**MOORE PUBLIC SCHOOLS -
RED OAK ELEMENTARY SCHOOL –
SECURITY UPGRADES AND CAMPUS ENCLOSURE**

CONSTRUCTION BULLETIN NO. 6

October 2, 2024

DEMOLITION FLOOR PLAN

A100

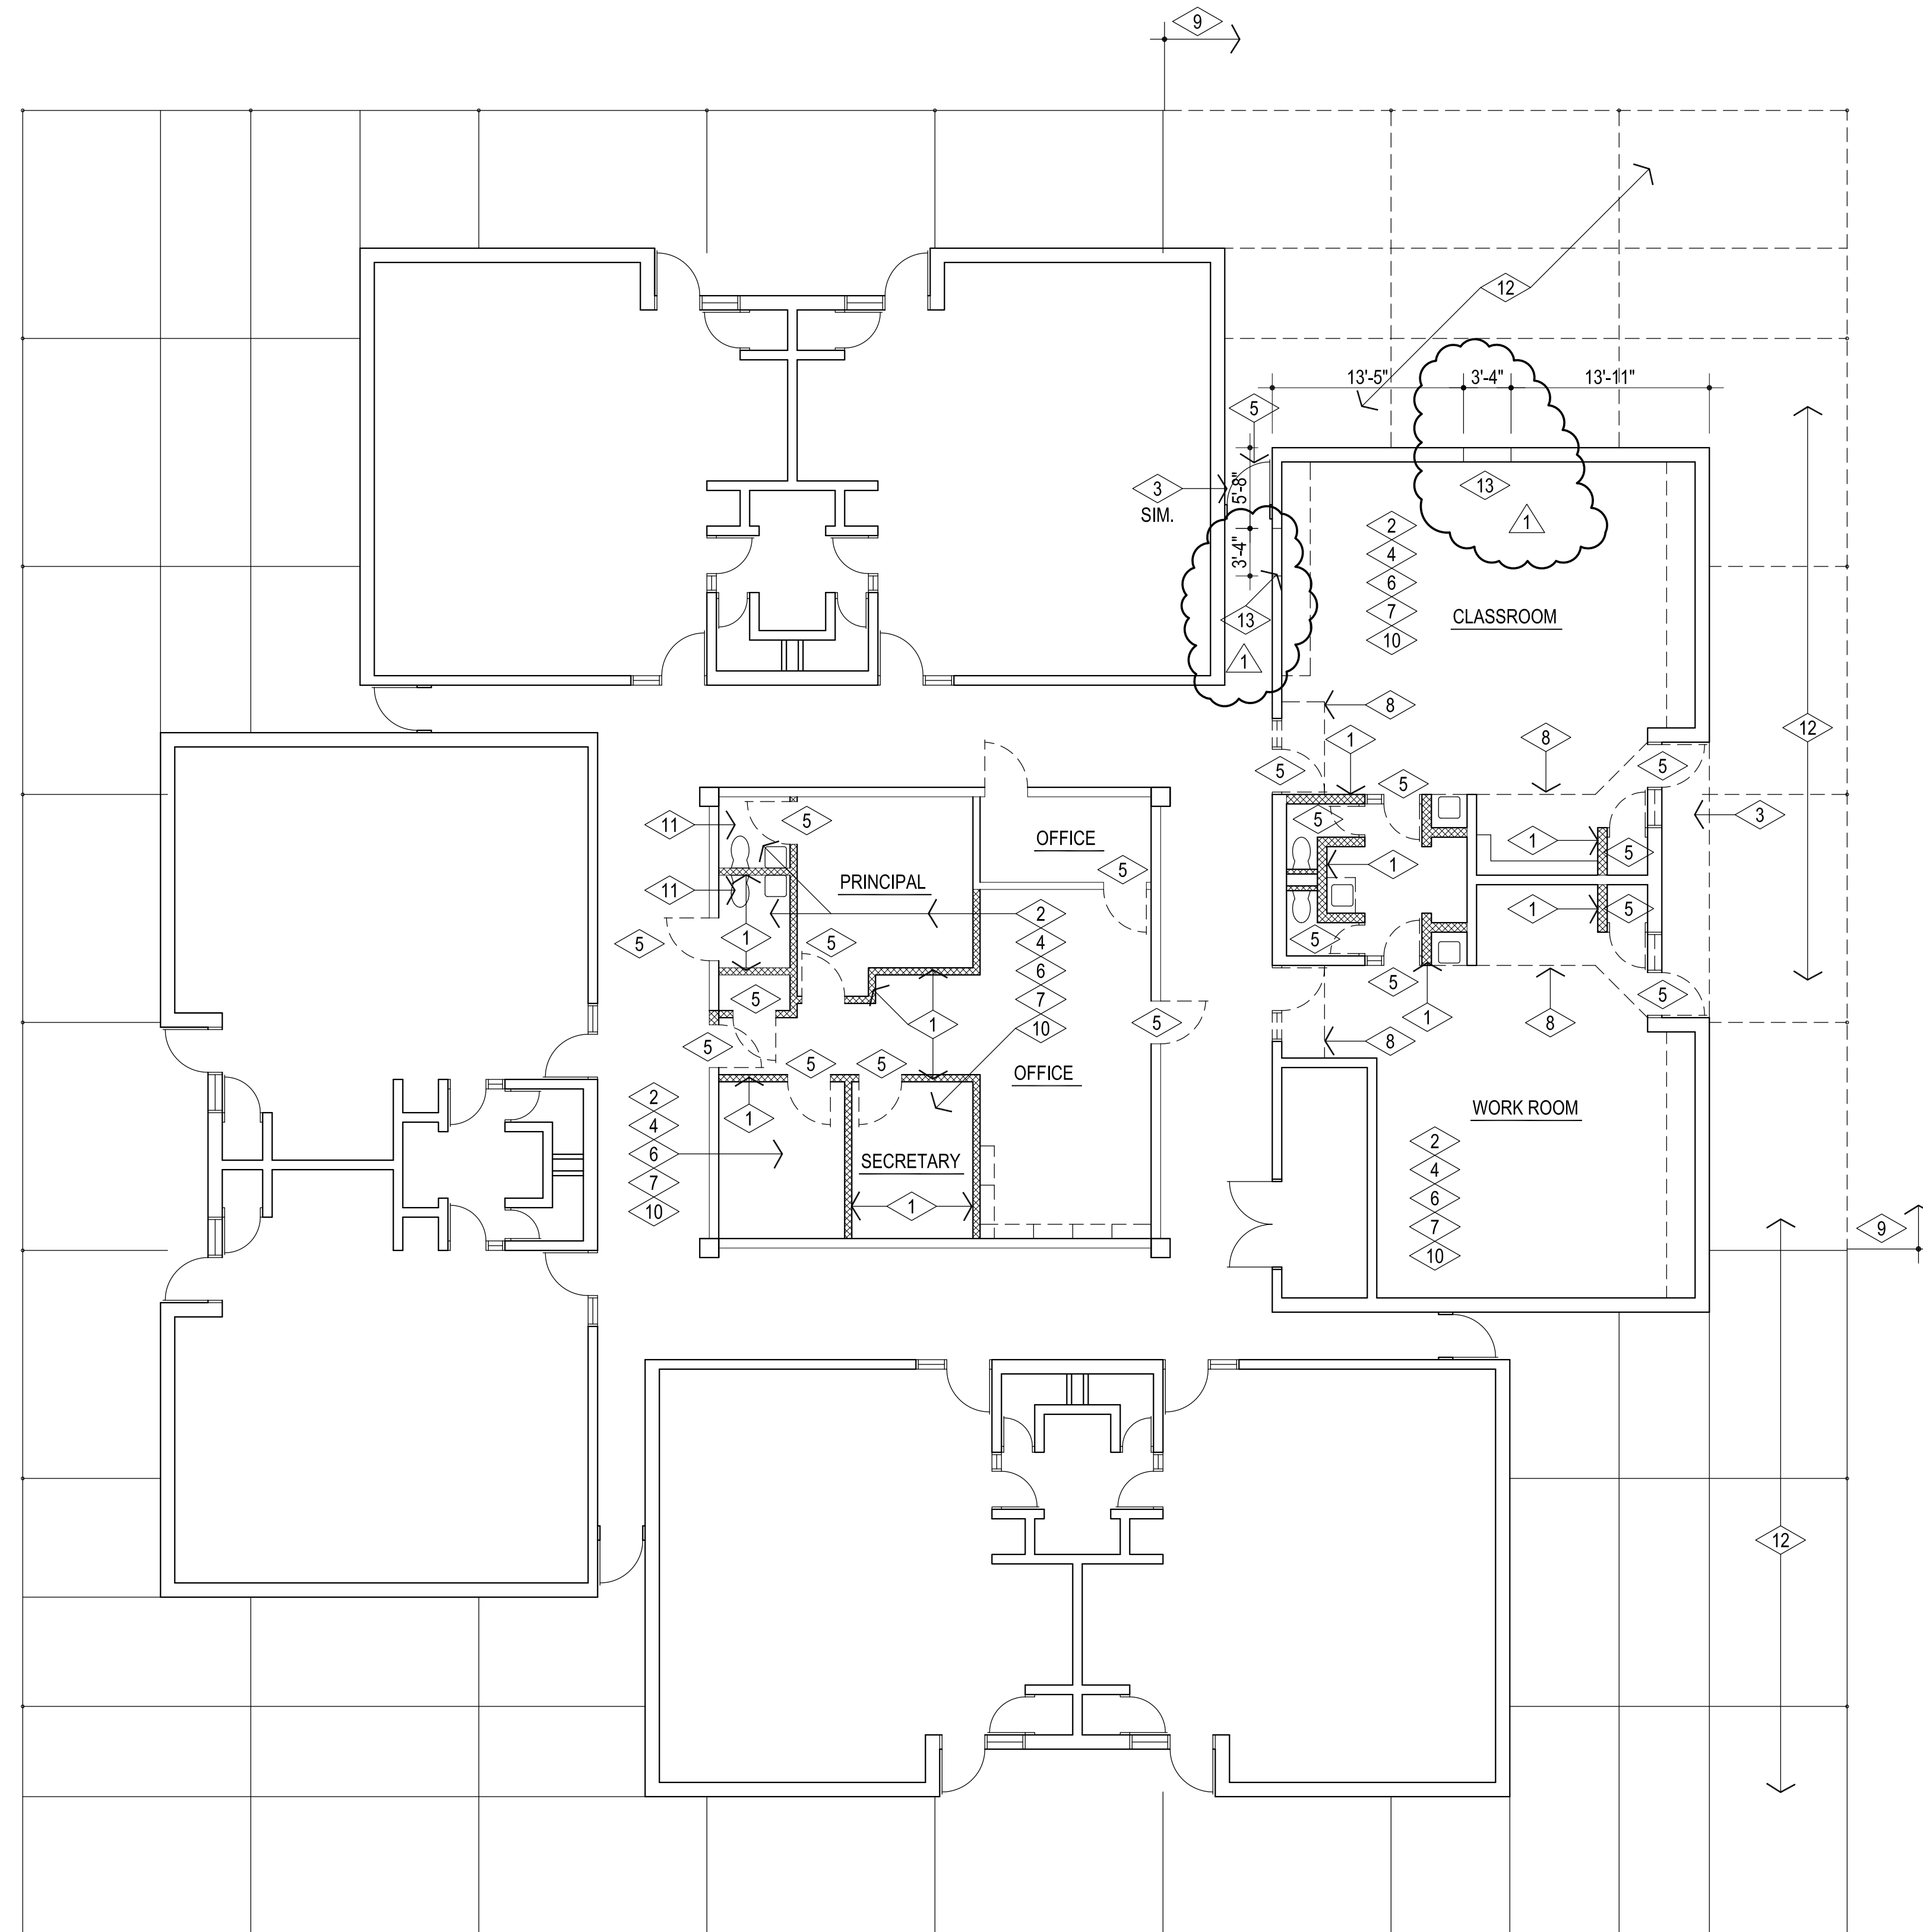
1. AT DOOR #11, PROVIDE FRAME "D" IN LIEU OF FRAME INDICATED IN PREVIOUSLY UPDATED DOOR SCHEDULES. PROVIDE TEMPERED / FIRE RATED GLAZING AT SIDE LITES AS REQUIRED FOR A 1 HR PARTITION. FIELD VERIFY EXISTING OPENING DIMENSIONS MATCH THE PROPOSED DOOR FRAME "D" PRIOR TO FABRICATION. REVISE HARDWARE ACCORDINGLY. PROVIDE TRIM, CONTINUOUS SEALANT, ETC. AROUND FRAME AT EDGES OF EXISTING PARTITION.
2. REFER TO REVISED SHEET A100 FOR ADDITIONAL INFORMATION CONCERNING THE PARTIAL WALL DEMOLITION REQUIRED FOR DOORS #6 & 9.
